MITSUBISHI MOTORS

SERVICE BULLETIN

PURPOSE : CORRECTION	ISSUE NO. : MSB-11E26-501	DATE : 2011-03-05
SUBJECT : FRONT CALIPER ASSEMBLY AND FRONT HUB ASSEMBLY MOUNTING BOLT TIGHTENING TORQUES		<MODEL> <M/Y>
GROUP : FRONT AXLE		(EUR/RUSSIA/ UK(Japanese Domestic Spec.)) See following 2. Applicable Manuals table.

AC704844AB

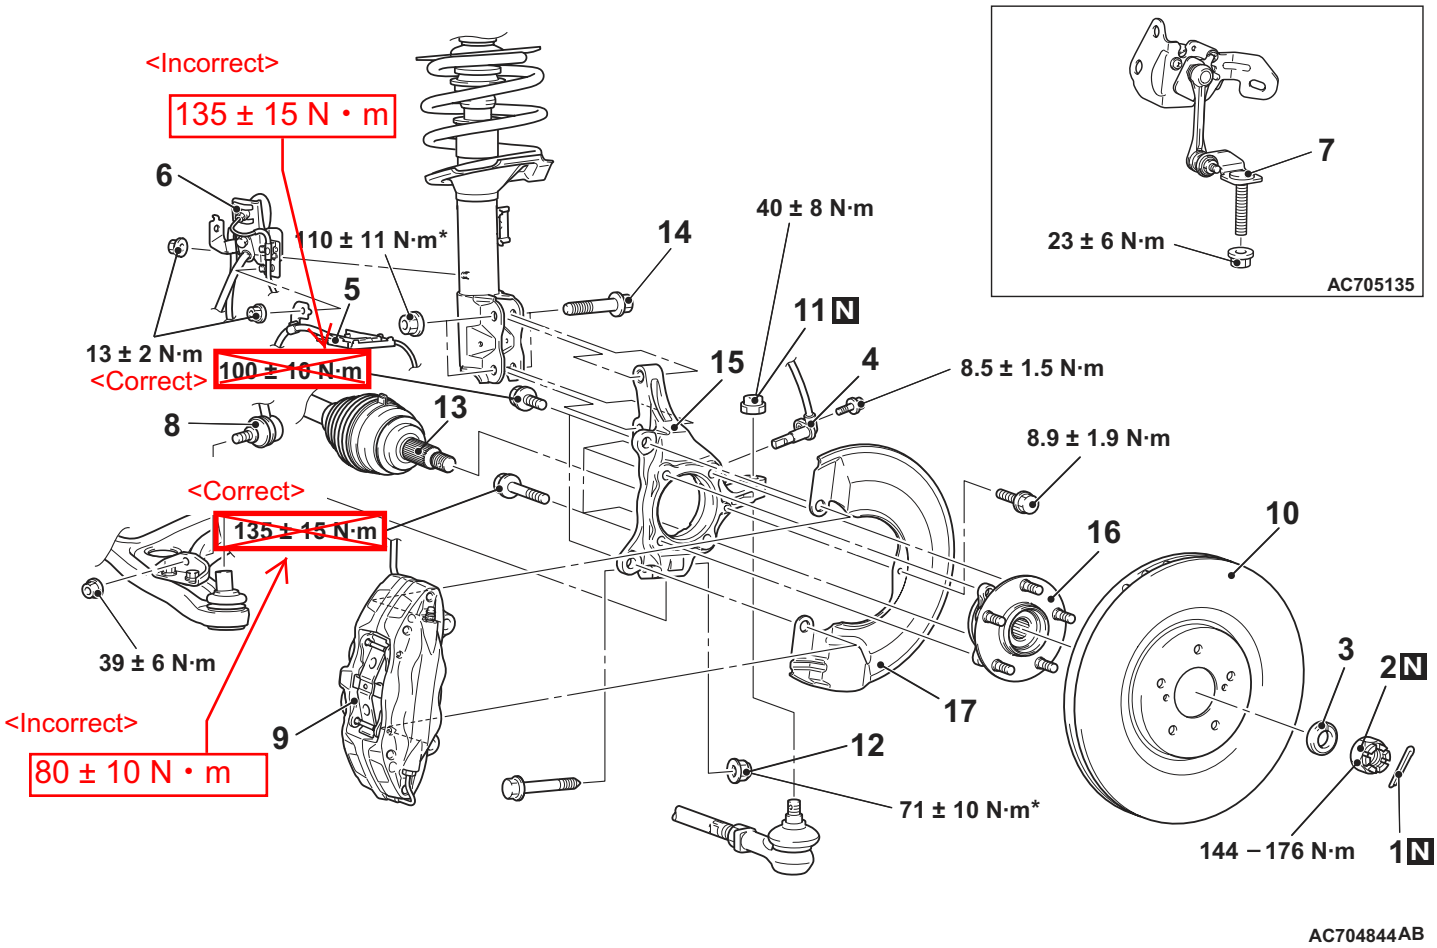
The tightening torque values for the front caliper mounting bolts and front hub assembly mounting bolts have been incorrect in the applicable Workshop Manuals. This Service Bulletin contains the corrected descriptions.

Removal steps
		1.	Split pin
<<A>>	>>B<<	2.	Front driveshaft nut
	>>B<<	3.	Washer
		4.	Front wheel speed sensor
		5.	Front wheel speed sensor harness clip
		6.	Brake hose bracket
		7.	Front height sensor to lower arm connection
		8.	Front stabilizer link and lower arm connection
<<B>>		9.	Front caliper assembly
<<C>>		10.	Front brake disk
<<D>>		11.	Self locking nut (tie-rod end connection)
		12.	Nut (lower arm ball joint connection)
<<E>>		13.	Front hub assembly and front driveshaft assembly connection
	>>A<<	14.	Knuckle and strut assembly connection bolt
		15.	Knuckle
		16.	Front hub assembly
		17.	Dust shield
